# SOLO EVENTS BOARD

## SOLO EVENTS BOARD | November 24, 2014

Figure 1 – Location of the Controlled Area

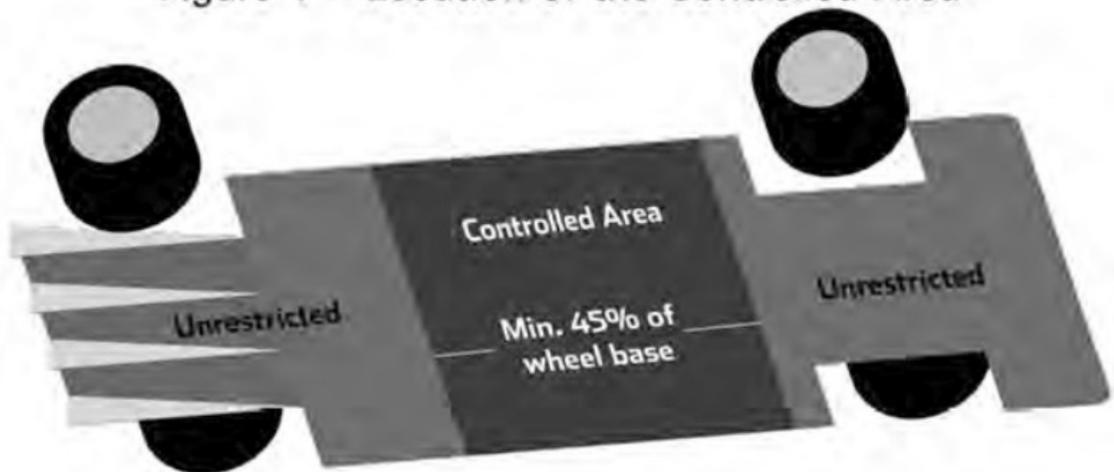
The following updated version of the B Modified proposal has been provided by the MAC in response to member input. (Changes from existing BM rules are shown in *red*. Deleted text is crossed out in *purple*.)

1. The total area when viewed from the top of **front and rear** wings shall not exceed 8 square feet. **Area calculation is of the airfoil element plan view and does not include side plates. Side plate area and element profile are unrestricted.**

2. **Cars with underbody features built in excess of P2 aerodynamic allowances (2015 GCR Section 9.1.8.C.1.E) must meet a weight penalty of 100 lbs. and must be constructed within the following limitations:**

a. **For the full width of the body the floor pan will be a minimum of 45% of the wheelbase; the lower surface (surface licked by the air stream) shall not exceed +/-2.54 cm (1 inch) deviation in any longitudinal section through the plane forming the bottom of the tub or chassis floor. The 45% minimum (of the wheelbase) dimension is measured from the point that the surface meets the full width of the body (behind the front wheel or in front of the rear wheel). (This is not to be interpreted as requiring a floor pan beneath the motor, transaxle, transmission, or final drive housing.) See Figure 1.**

b. **No aerodynamic devices (e.g. "skirts," body sides, etc.) may extend more than 1cm (0.394 inches) below this lower surface anywhere on the car to the rear of the front axle. Seat bucket or other protrusions shall not circumvent this rule.**

Figure 1 – Location of the Controlled Area

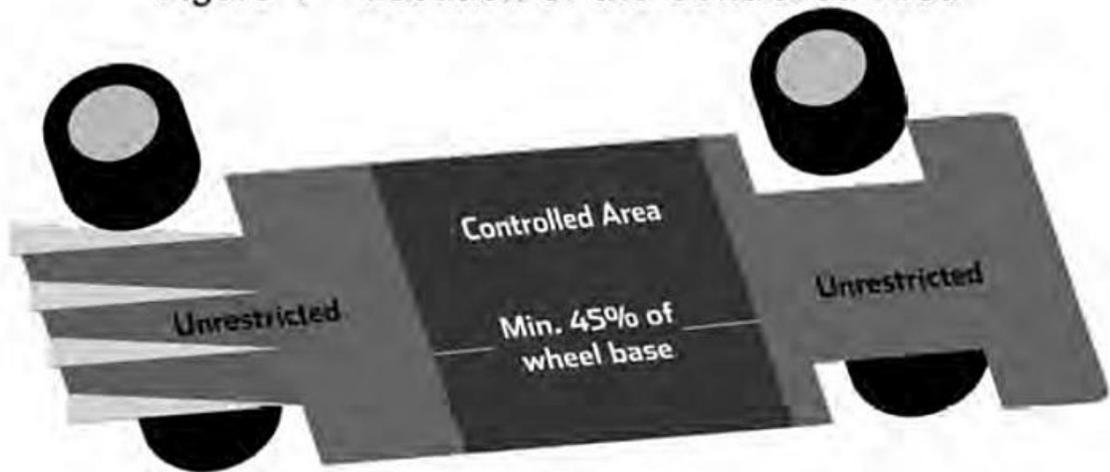
The MAC is recommending the accompanying final version of the B Modified proposal.

2. *Cars with underbody features built in excess of P2 aerodynamic allowances (2015 GCR Section 9.1.8.C.1.E) must meet a weight penalty of 50 lbs. and must be constructed within the following limitations:*

a. For the full width of the body the floor pan will be a minimum of 45% of the wheelbase; the lower surface (surface licked by the air stream) shall not exceed +/-2.54 cm (1 inch) deviation in any longitudinal section through the plane forming the bottom of the tub or chassis floor. The 45% minimum (of the wheelbase) dimension is measured from the point that the surface meets the full width of the body (behind the front wheel or in front of the rear wheel). (This is not to be interpreted as requiring a floor pan beneath the motor, transaxle, transmission, or final drive housing.) See Figure 1.

b. No aerodynamic devices (e.g. "skirts," body sides, etc.) may extend more than 1cm (0.394 inches) below this lower surface anywhere on the car to the rear of the front axle. Seat bucket or other protrusions shall not circumvent this rule.
